**ADDENDUM NO. 2**  
for  
**22-0028-UT East Water Reclamation Facility Screw Pump**  
Clearwater, Florida

DATE: April 22, 2024  
SUBJECT: Addendum No. 2  
TO: Prospective Bidders and Others Concerned

**DRAWING MODIFICATION:** See attached modifications of Contract Drawing Sheets S1 and S2 with respect to the addition of access platforms.

EXPANSION JOINT REPAIR - SLAB OR WALL

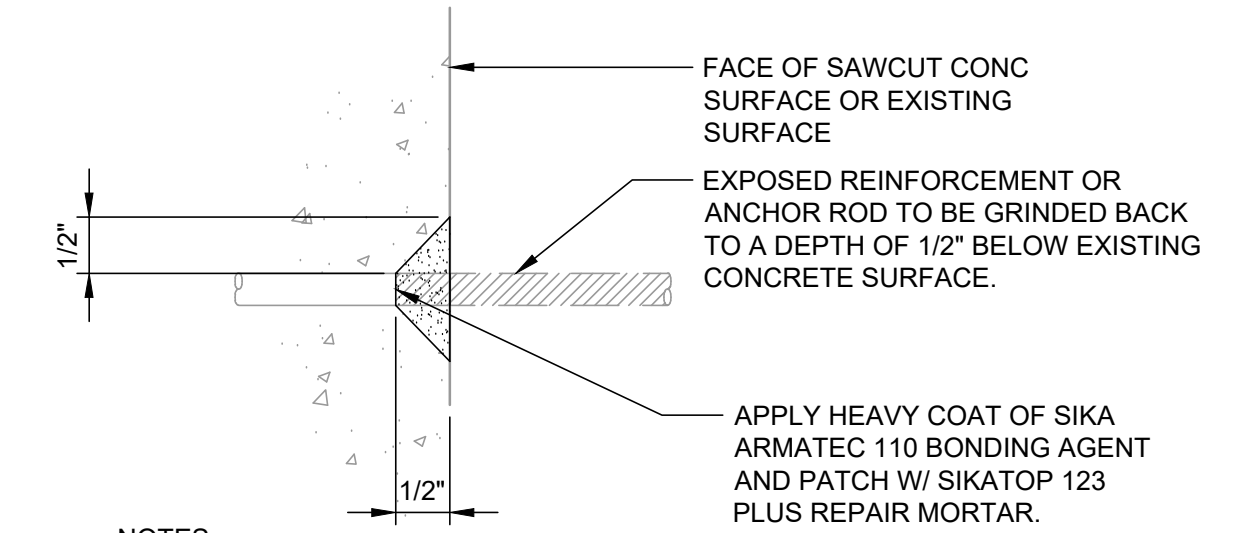
**14. Question:** Please confirm that the only 2 areas requiring expansion joint repair are the 2 vertical areas called out on page S2 of the plans. Please provide the number of linear feet of expansion joint requiring repair. Again, the need for repair is a matter of opinion and what requires repair and what doesn't is open to interpretation and could be evaluated differently by the bidders.

Item 6. Expansion Joint Repair – This item include the repair of expansion joints in accordance with detail A on Sheet S1 of the Contract Drawings. Payment for this item will be based on actual unit quantity of expansion joint repaired in accordance with the Contractor's Bid Item and Approved Schedule of Values and upon City verification.

CONCRETE REPAIRS AT WALL AND SLAB SURFACES

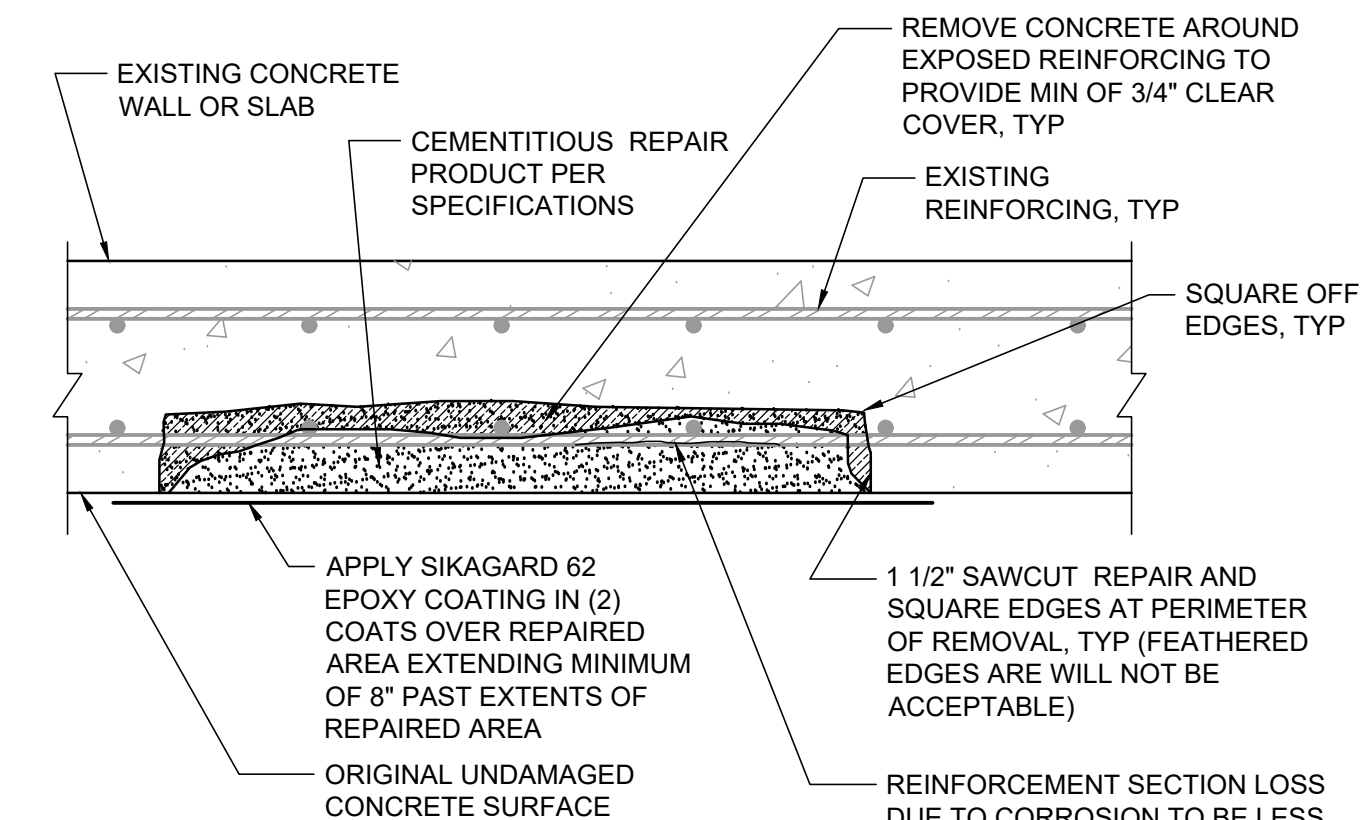
**13. Question:** After reviewing Addendum 1 and participating in the site visit, there still is not enough information to provide accurate pricing for the spall repair. For spall repair the plans state to repair “damaged, degraded and spalled surfaces”. However, “damaged, degraded and spalled” is not defined anywhere that we can see. After visiting the site we observed some damage over the entire structure. This observed damage though only appears to be damaged in our opinion. We cannot get quotes or accurately provide pricing based on “a minimum of 10 SF”, especially when terms aren’t defined and are open to interpretation. Besides this, spall repair is done based on the volume of material used. Without knowing how deep each area is we would have to base our bid on worst-case-scenario and could end up costing the City a lot of money. Example: for the effluent channel we would have to assume, for bidding purposes, that the entire channel needs repair in order to mitigate our risk. Recent bids we have participated in with spall repair have included bid items such as “10 SF of spall repair, assuming ½” depth” and “10 SF of spall repair, assuming 1” depth and exposed reinforcing steel”, etc. I would ask that unit price bid items be added for this bid in a similar way. This will allow all participating bidders to get accurate quotes and bid the same work without a difference of opinion.

**Answer:** See attached revised Bid Form. Bidders shall provide the spall repair in accordance with Detail B. This detail requires the saw cutting of the edge of spalls (1-1/2” deep) and the removal of concrete around existing reinforcement to 3/4” clear behind the

reinforcement. The reinforcement shall be assumed to have 2” of concrete cover. The areas to be repaired will be specifically identified by the EOR during construction.

Item 5. Spall Repair – This item includes providing spall repair in accordance with detail B on Sheet S1 of the Contract Drawings. The Contractor shall be responsible for saw-cutting the edge of spalls 1.5-inches deep and removing the concrete around existing reinforcement to 0.75-inches clear behind the reinforcement. The reinforcement shall be assumed to have 2-inches of concrete cover. The areas to be repaired will be specifically identified by the engineer of record during construction. Payment for this item will be based on actual unit quantity of spall repair performed in accordance with the Contractor's Bid Item and Approved Schedule of Values and upon City verification.

EAST WRF  
SCREW PUMP REPLACEMENT  
**SCREW LIFT STATION PLAN  
AND SECTION**

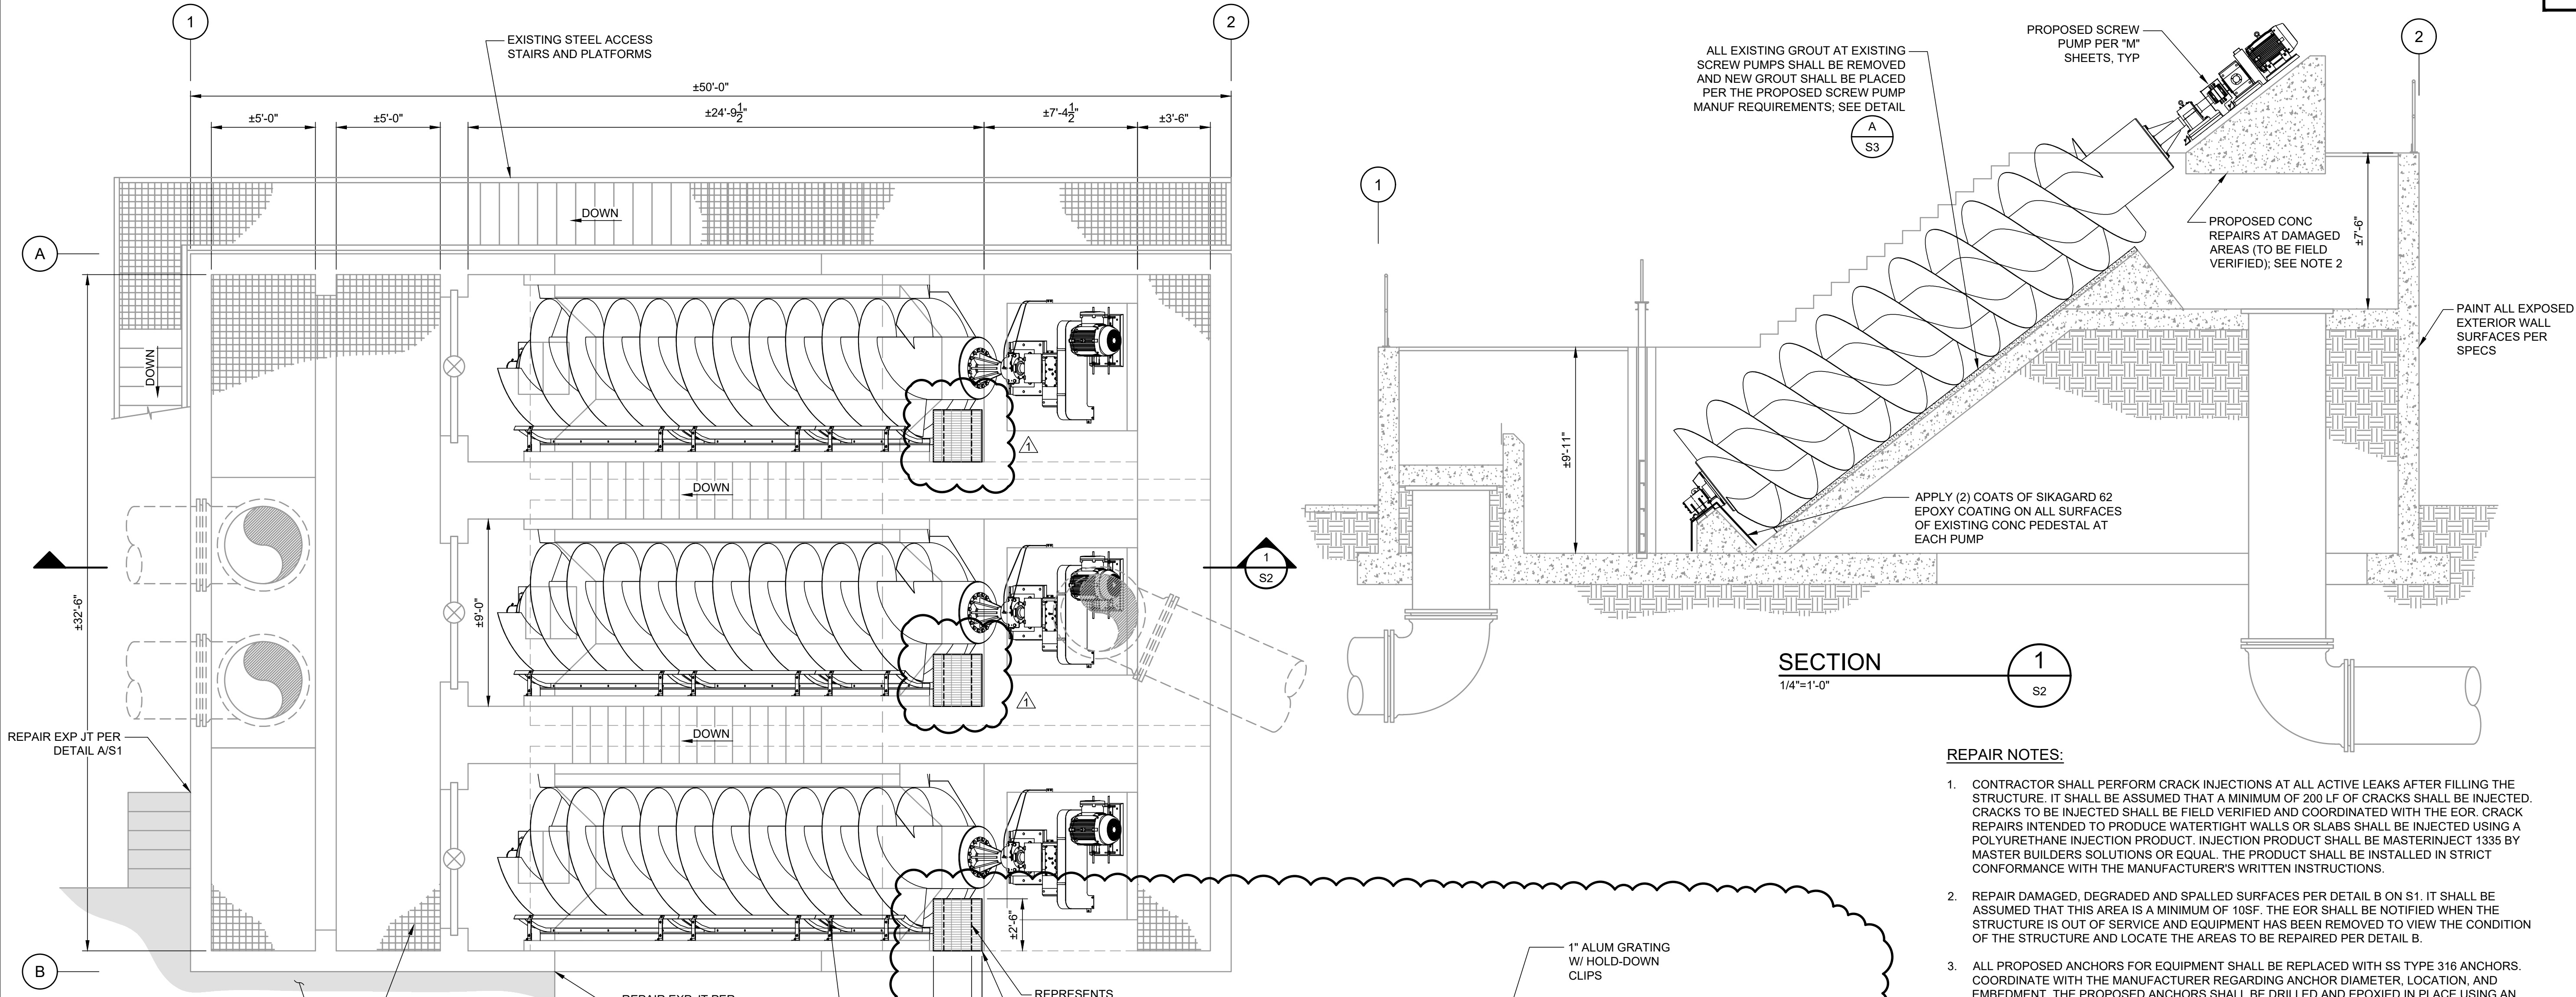
**15. Question:** Sheet S2 of the plans show a “Sikagard” coating system only at the lower concrete pump pedestals. However, the specs have systems called out for submerged concrete, submerged metals, etc. Please provide a detailed finish schedule outlining any other required coating on any of the surfaces for the interior of the structure.

**Answer:** See attached revised Bid Form.

**Answer:** None of the concrete needs to be coated except where explicitly stated in the Drawings (at the pump pedestal and at the possible damaged areas). No stainless steel metal needs to be coated. Equipment shall be painted and coated in accordance with the specification and requirements of the manufacturer.

- CONTRACTOR SHALL PERFORM CRACK INJECTIONS AT ALL ACTIVE LEAKS AFTER FILLING THE STRUCTURE. IT SHALL BE ASSUMED THAT A MINIMUM OF 200 LF OF CRACKS SHALL BE INJECTED. CRACKS TO BE INJECTED SHALL BE FIELD VERIFIED AND COORDINATED WITH THE EOR. CRACK REPAIRS INTENDED TO PRODUCE WATERTIGHT WALLS OR SLABS SHALL BE INJECTED USING A POLYURETHANE INJECTION PRODUCT. INJECTION PRODUCT SHALL BE MASTERINJECT 1335 BY MASTER BUILDERS SOLUTIONS OR EQUAL. THE PRODUCT SHALL BE INSTALLED IN STRICT CONFORMANCE WITH THE MANUFACTURER'S WRITTEN INSTRUCTIONS.

- REPAIR DAMAGED, DEGRADED AND SPALLED SURFACES PER DETAIL B ON S1. IT SHALL BE ASSUMED THAT THIS AREA IS A MINIMUM OF 10SF. THE EOR SHALL BE NOTIFIED WHEN THE STRUCTURE IS OUT OF SERVICE AND EQUIPMENT HAS BEEN REMOVED TO VIEW THE CONDITION OF THE STRUCTURE AND LOCATE THE AREAS TO BE REPAIRED PER DETAIL B.

GATE SCHEDULE

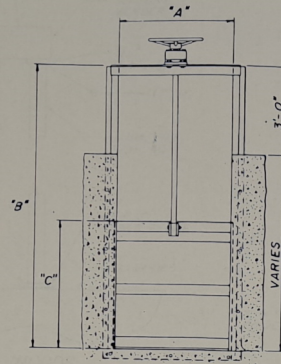
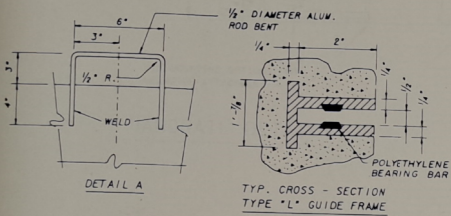
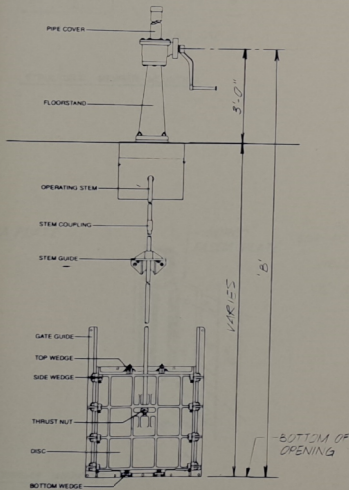
**4. Question:** During the site visit, it was noticed that the valve tag on the existing slide gates states "80 x 72" and "J8775", however, this does not match the information that was provided in Addendum 1. Can O&Ms consistent with the information provided on the existing valve tags please be provided?

**11. Question:** The Waterman representative came out to the site visit. They noticed Valve Tag stated 80 x 72 & J8775 on the existing gates. This doesn't match what the city provided in the Addendum 1. Addendum 1 stated the "Screw Lift Pump Station Mark 12 has a qty of 4 and the sizes are 74 x 66 for Job Number J-8039-2. Can you provide the correct submittal data sheet for these slide gates 80 x 72 & J8775?

**Answer:** City provided O&M manual from the same manufacturer for a similar installation within the City. The details in the O&M provided are generally accurate for the gates installed at the Clearwater East Facility. There is not an O&M available for the gates specifically installed at this facility. Bidders are directed to reference the O&M from Addendum No. 1 for gate operation and equipment details. See attached Record Drawing of Gate Schedule for East WRF gates.
